# **Proposal for Modification of Frontal Impact Test Bench for Booster Type CRS**

## **Answers to Comments from IG CRS**

# Seat Bench Geometry in Cars

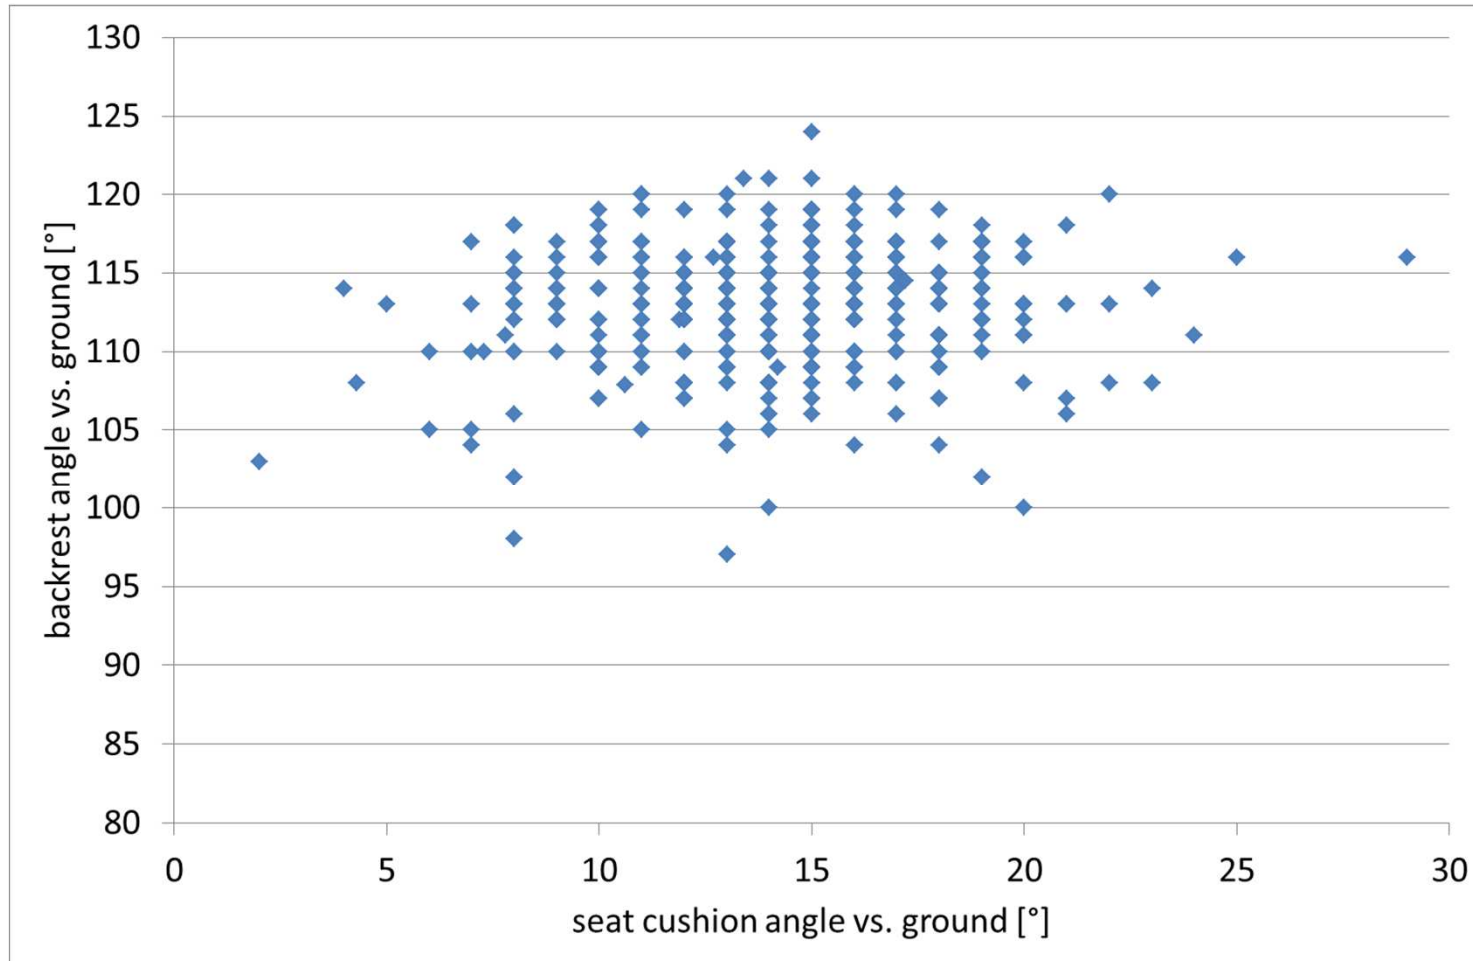
## Turn Complete Bench instead of Modifying Cushion Angle

- The proposal is to develop a test bench that is more representative of worst case situation w.r.t. submarining.
  - Avoidance of abdominal loading is the main objective of booster type CRS
  - The capabilities of the booster cannot be assessed on a test bench that does not allow submarining without CRS
- There is no correlation between seat cushion angle and backrest angle in cars (see next slide)
- The larger the torso angle the larger the submarining risk
- Rotation of the complete test bench seems to be a quite big effort for experimental analysis
- Following that Berlin experts do not propose to turn the complete test bench
